Subject: The Dow Chemical Company- License No. R-108; Docket No. 50-264

Enclosed is the DTRR Revised responses to RAI questions 6, 11, 15-1, 17-1, 17-3, 34, 35, 36-2, 41, 52, 54, 56, 57, 61-3, 62-2, 64-1, 65-1, 65-2 in support of the license renewal.

DTRR Revised response to questions 6, 11, 15-1, 17-1, 17-3, 34, 35, 36-2, 41, 52, 54, 56, 57,  
61-3, 62-2, 64-1, 65-1, 65-2

Figure 4. Upper grid

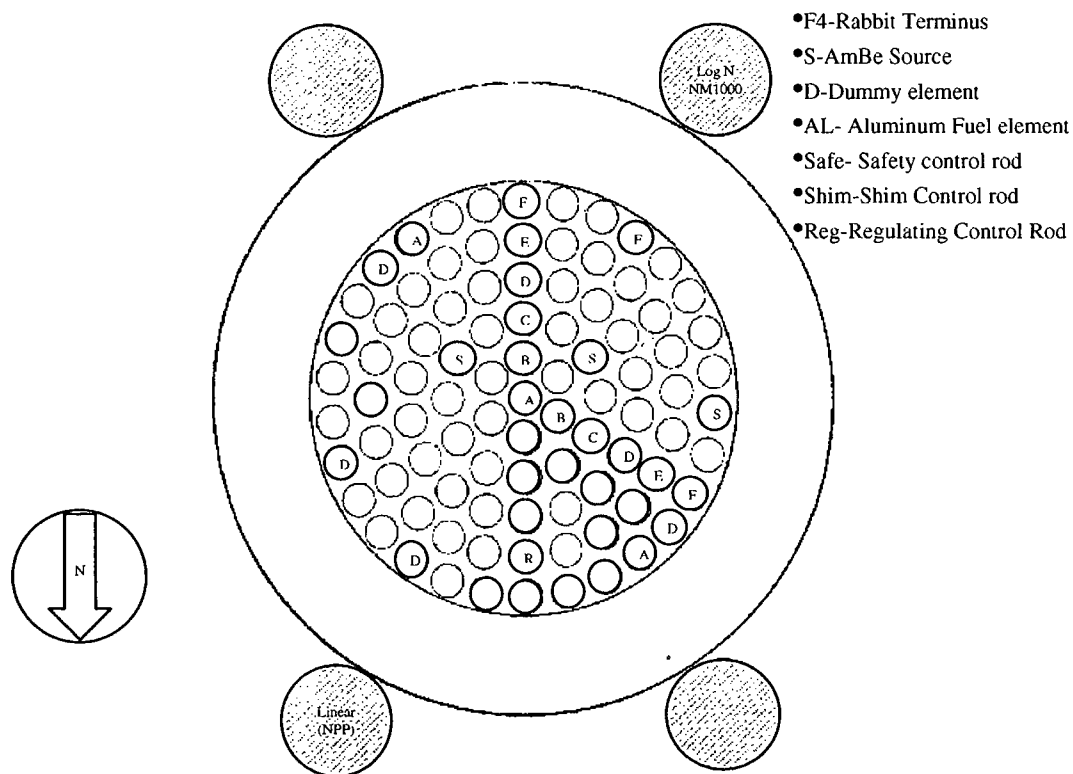
11. NUREG-1537, Part 1, Section 4.2.5, "Core Support Structure" requests the applicant to provide design information pertaining to the core support structure. DTRR SAR, Chapter D, does not provide sufficient information. Please provide figures depicting the upper and lower core plates and provide the dimensions and locations of all penetrations that allow coolant to flow through them.

Two aluminum grid plates fix the position of fuel elements, dummy elements and neutron source. Figure 4 is the schematic drawing of the upper grid plate with the position of the control rods, pneumatic transfer location and source indicated. The upper plate is ¾ inch aluminum and 1.5 inch diameter holes to position the fuel, dummy elements, control rods, etc. The bottom plate is ¾ inch aluminum and has holes to receive the end pins of the fuel and dummy elements. Thirty-six holes for the natural convection cooling are found on the lower grid plate. The water passes through the upper grid plate by means of the gap between the triflute section of the fuel and the upper grid plate. The penetrations on the lower grid plate are in concentric rings with 7, 12, and 17 holes, respectively. Figure 5 is a photograph of the lower grid plate. This photograph substantiates the as built drawings given by General Atomics, and previous Safety Analysis

In addition to these holes, the fuels are raised above the bottom grid plate by the fuel pin ( $5/8$ " diameter by 2" long). The gap between the fuel and the lower grid plate therefore allows the bottom coolant to flow, in an "open" configuration through the core from the bottom.

Figure 1. Upper grid plate

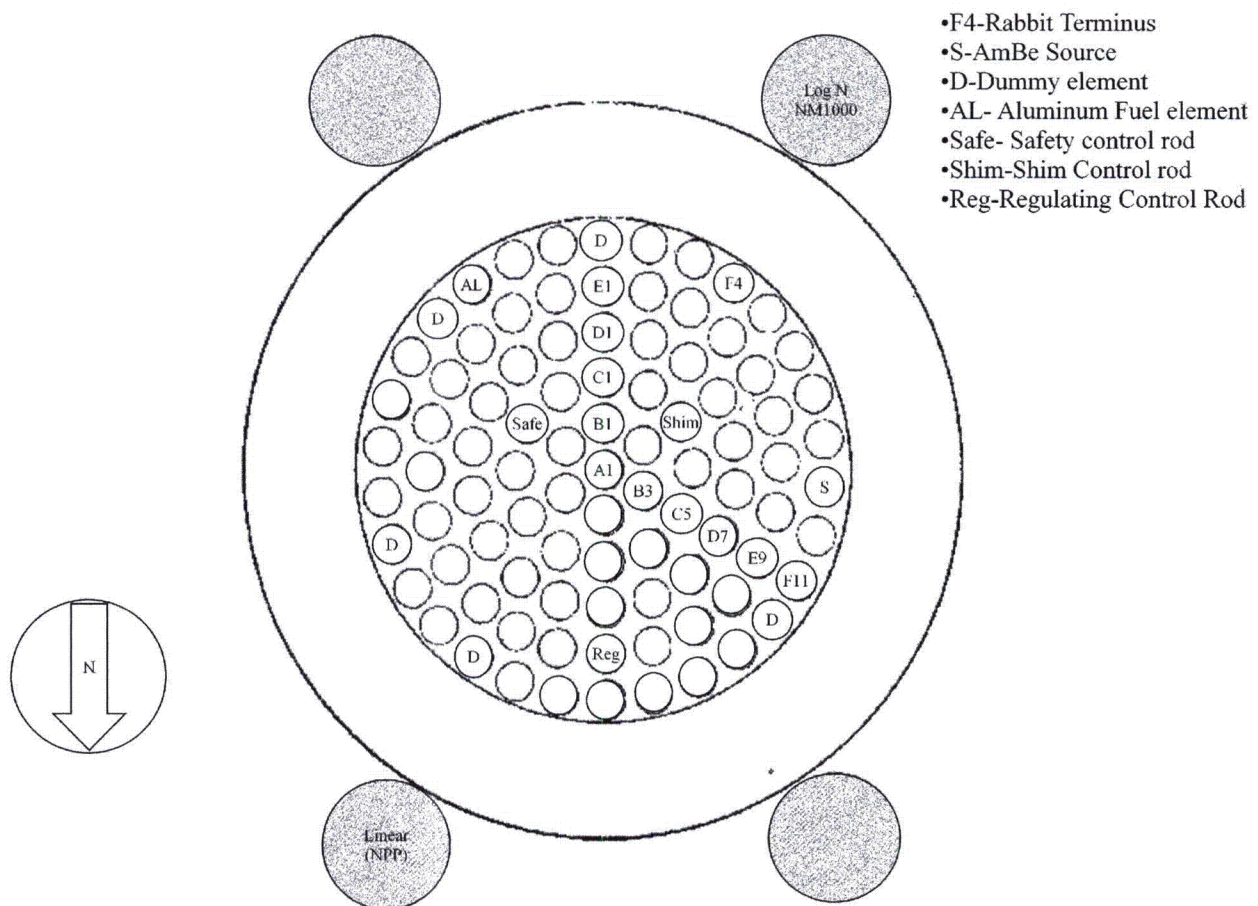
15.1 DTRR SAR, Section D.5.5, provides a list of reactivity worths but control rod worths are not included. Please provide control rod worths specific to the LCC at the requested power level.

15.2 DTRR SAR, Section A.3, describes the original fuel configuration as having 75 stainless steel (SS)-clad elements and one Aluminum (Al)-clad element. The DTRR SAR does not provide information relating to the DTRR fuel element and control rod layout for the requested power level. Please provide a complete description of the LCC for the requested power level and provide a core diagram showing all components.

The reactivity worth of the control rods are Shim1 \$2.68, Shim2 \$2.73, Regulating rod \$1.01 as measured on January 11<sup>th</sup>, 2011.

Figure 34: Reactor room HVAC system showing Inlet and outlet units

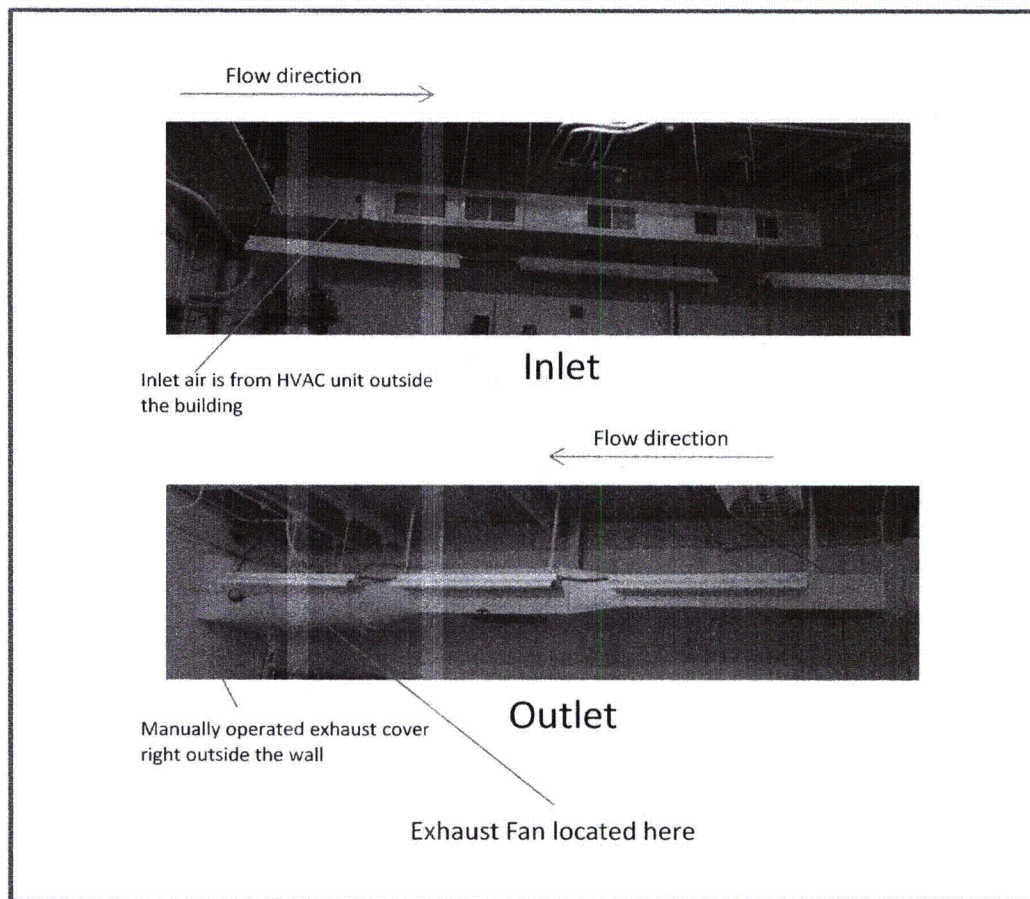
34. NUREG-1537, Part 1, Section 9.1, "Heating, Ventilation and Air Conditioning System" requests the applicant to provide a description of the heating, ventilation and air conditioning system (HVAC) and any manual or automatic functions. There is a brief description in DTRR SAR I.1 regarding this function with no schematics or illustrations. Please provide a more detailed description of the HVAC system and system functions and provide schematics of the HVAC system.

The HVAC for the reactor room of the DTRR is shown in Figure 34. The inlet to the reactor room is located to the north side of the reactor room. The outlet is located on the east wall of the reactor room. Both the inlet and the outlet fans can be shut off using a switch in the control room. There are two modes of operation of the HVAC system, 1) Normal operating mode and 2) Isolation mode. In the normal operating mode, both fans are operating and air is being sucked out of the reactor room and "conditioned-air" is being pumped in at the specified turnover rate. There are indicators, available to the operator, of the system status. These indicators are checked daily or whenever the reactor is operated. In the isolation mode, both fans are turned off and the doors are closed. There is a manually operated shutter outside the building which covers the exhaust. This shutter, which is normally opened, will be closed during isolation mode. There are no filters in the exhaust.

**Figure 54. Diagram of Reactor Room and Adjacent Areas**

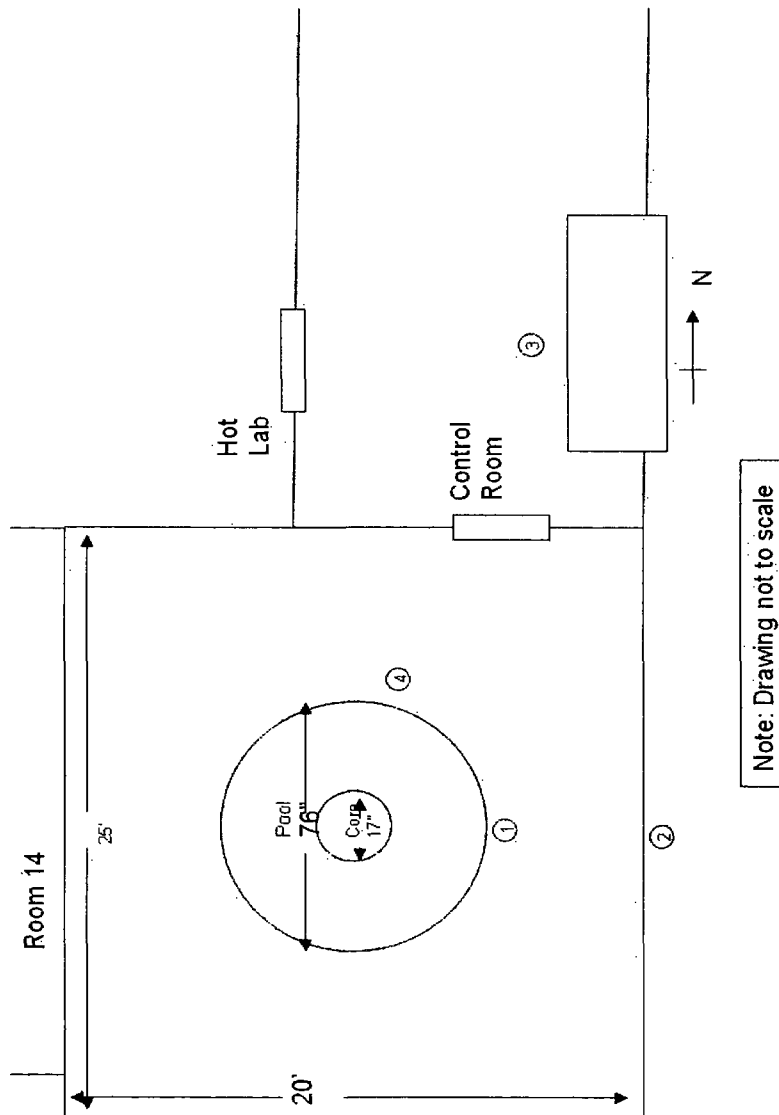
54. NUREG-1537, Part 1, Section 13.1.3, "Loss of Coolant" requests the applicant to provide analysis that assures that doses to the public that could result from a loss of coolant accident do not exceed 10 CFR Part 20 limits. DTRR SAR, Section M.1.1, Table 7 presents exposures resulting from a loss of coolant accident. There is no statement regarding occupational or public dose limits and whether they are met. Please explain this accident analysis in further detail and in terms of meeting the regulatory limits.

The water level in the surrounding area is above the core height and therefore tank breach will not result in a total loss of coolant. However, the analysis was completed for an uncovered core after an extended period of operation at 300 kW. The results are in the following table.

The elevated radiation fields generated from this accident will be highly collimated above the reactor pool. The core sits inside a 17" diameter opening in the reflector. The top of the reflector is 16' below the top of the 76" diameter reactor pool. Based on the largest potential angle that direct radiation may be emitted from the reactor, the direct radiation beam from the core will only have a diameter of 12.3 feet at the roof of the reactor room, which is still much smaller than the entire room. Therefore, workers and members of the public located outside of the reactor room will not be exposed to the direct radiation from the reactor core. Responders to the incident will also avoid the area of the room directly above the core in order to avoid exposure to the direct radiation from the reactor core.
